## Charlotte-Mecklenburg Planning Department

**SUBJECT:** Administrative Approval for Petition No. 2006-131 Catellus Group, LLC

**Archdale Mixed Use Development "MONTPARNASSE"**  
 Catellus Group, LLC  
 CHARLOTTE, NORTH CAROLINA

SITE PLAN

SP1.1

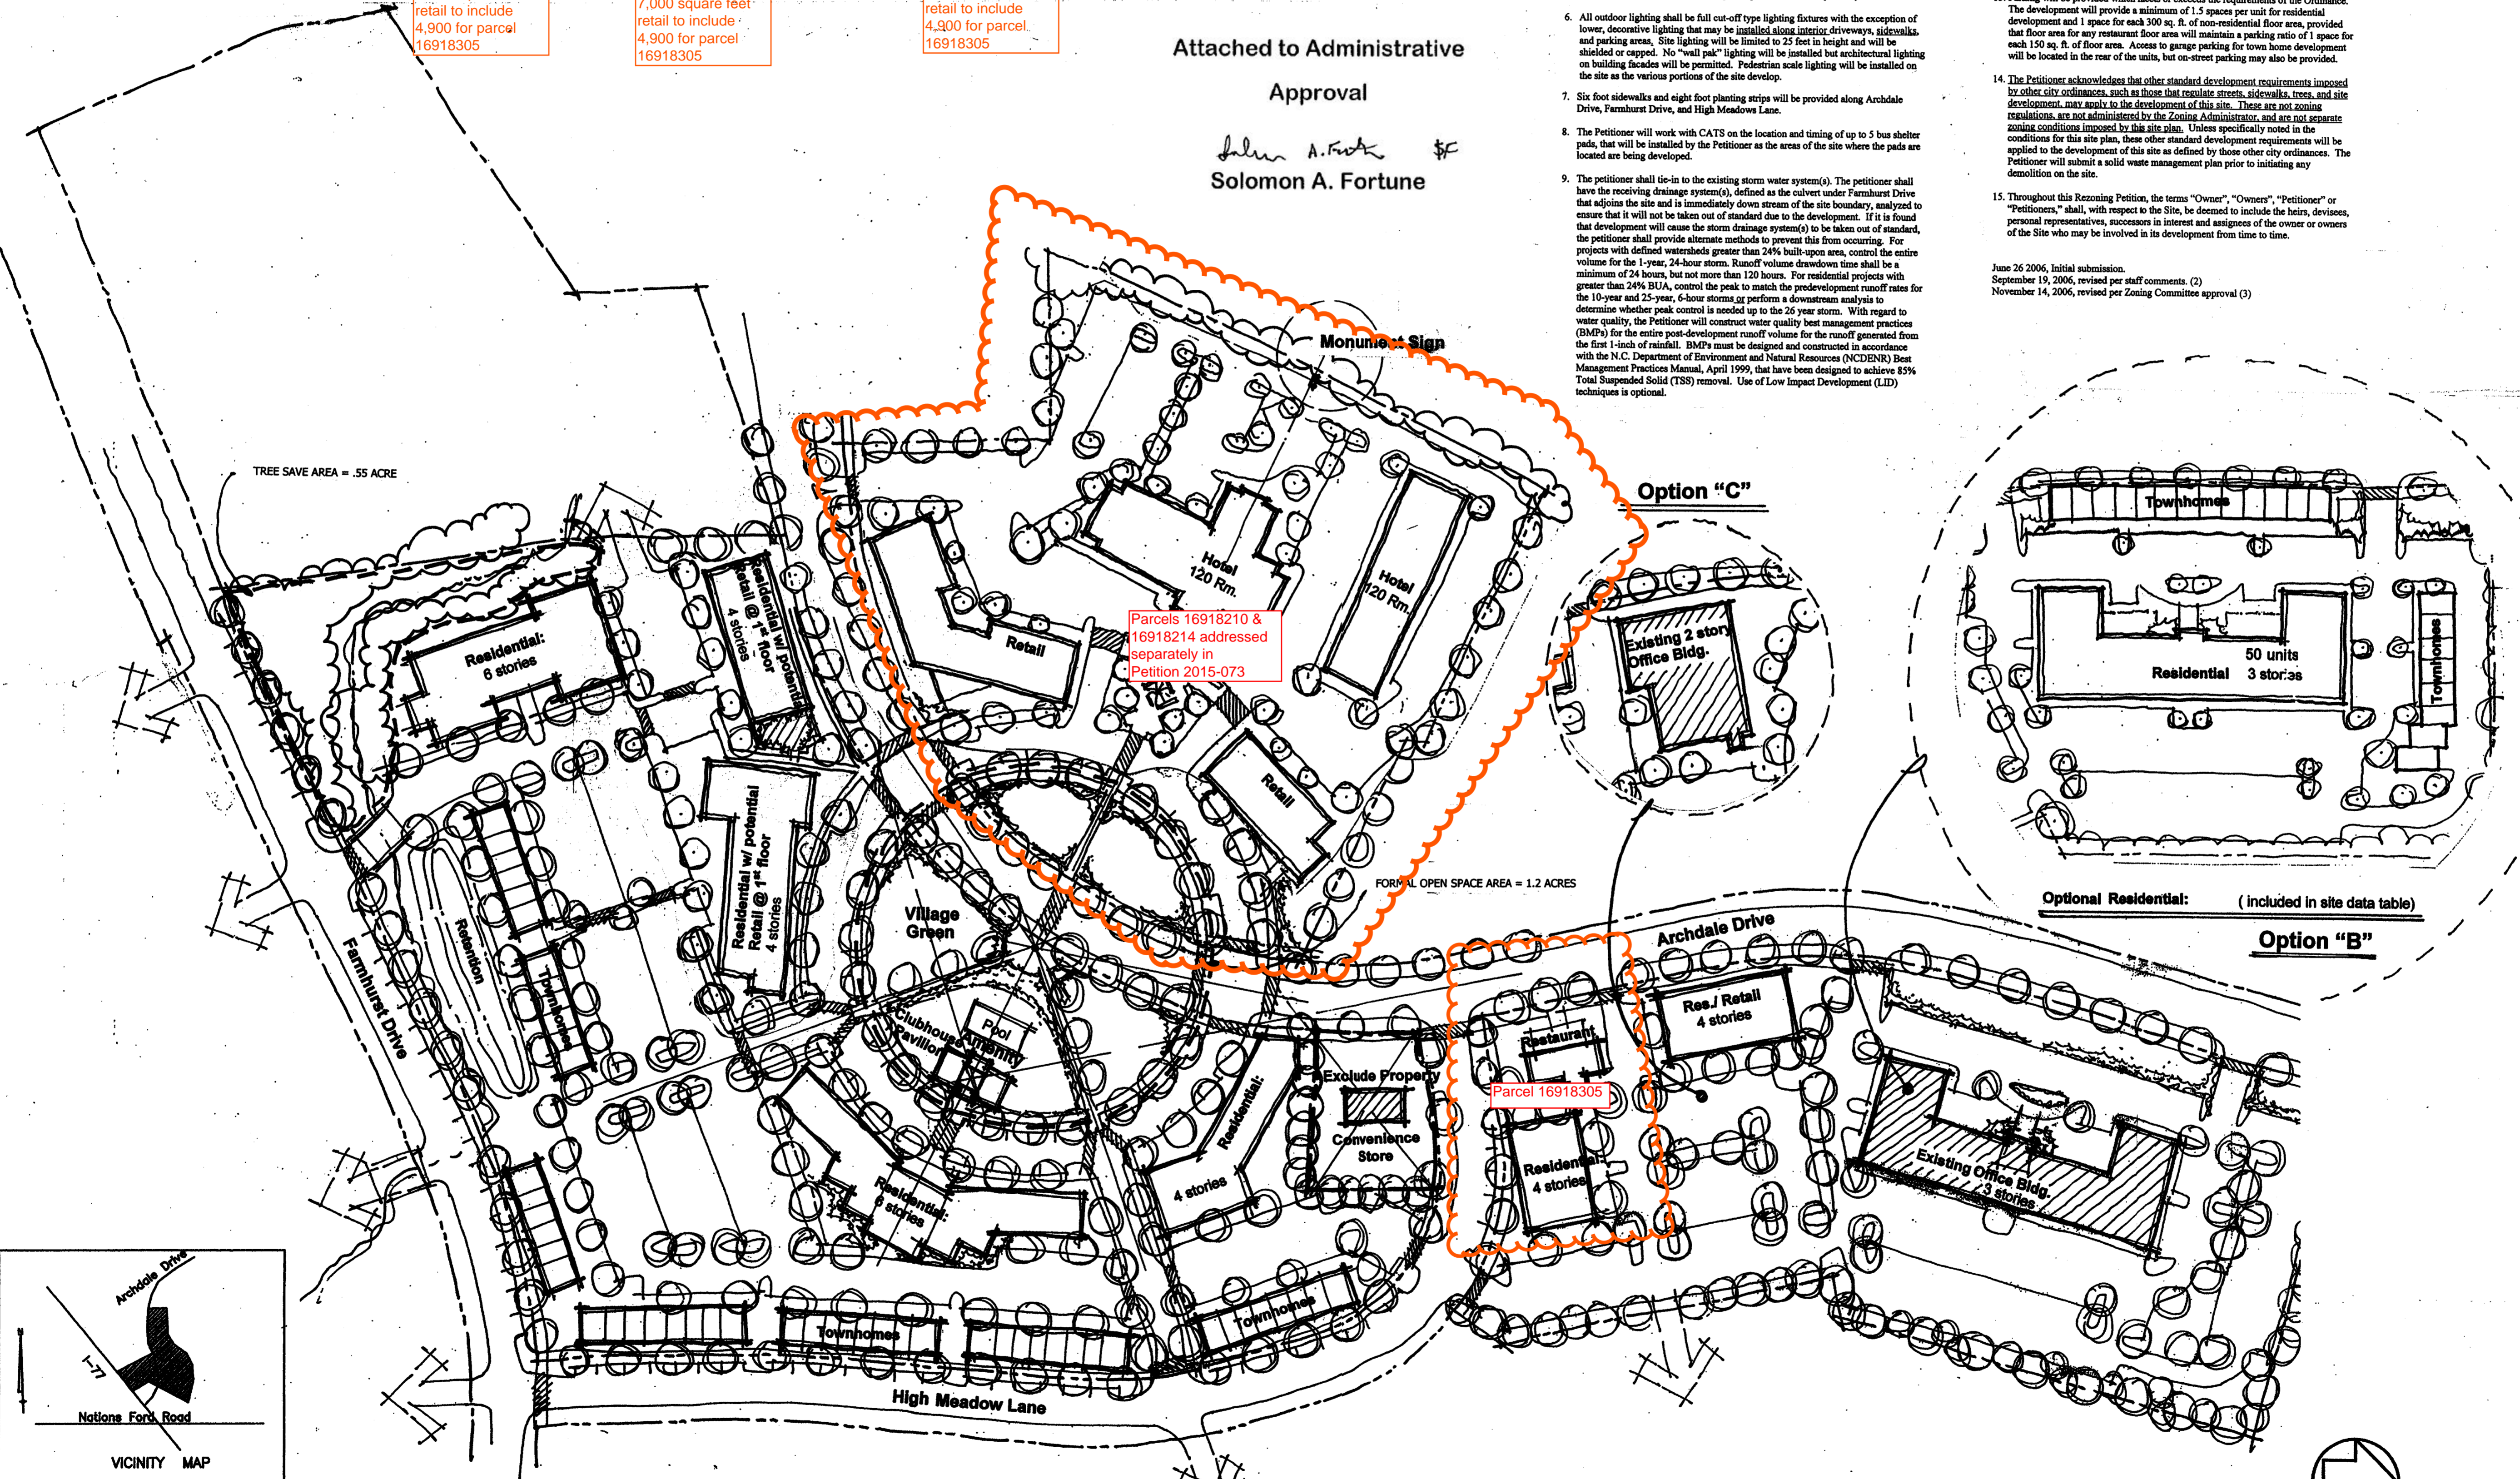
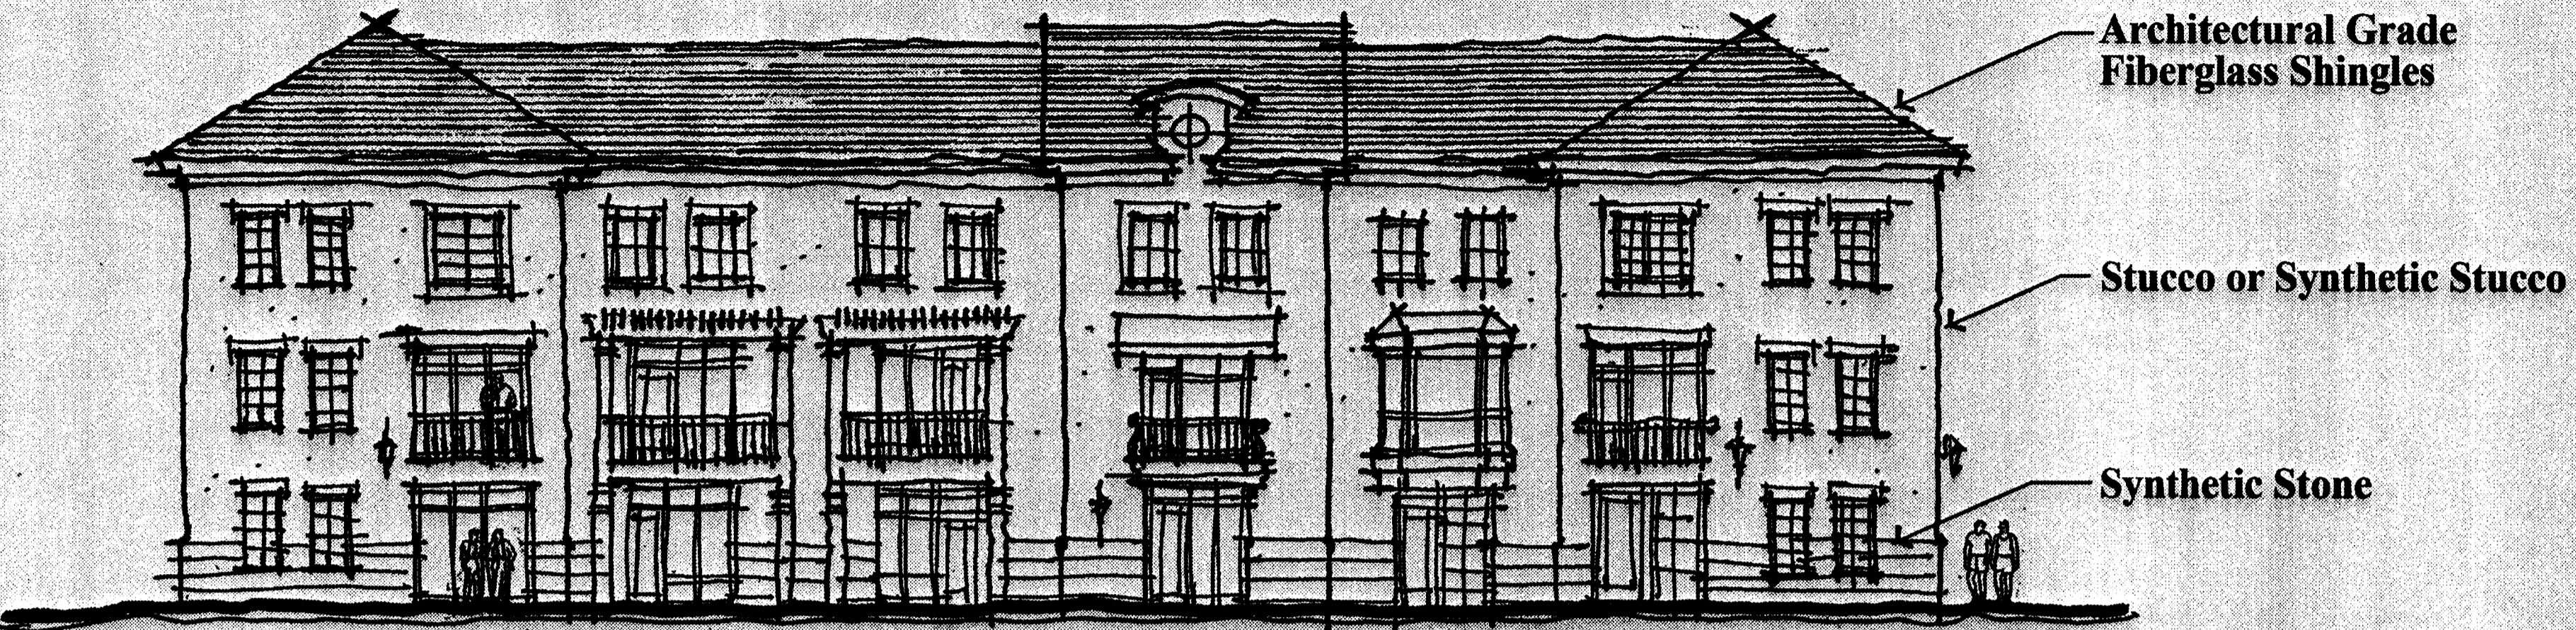
- Proposed reduction of retail square footage for parcels.
- Removal of parcel covered under petition 2015-073.

7,000 square feet retail to include 4,900 for parcel 16918305

7,000 square feet retail to include 4,900 for parcel 16918305

7,000 square feet retail to include 4,900 for parcel 16918305
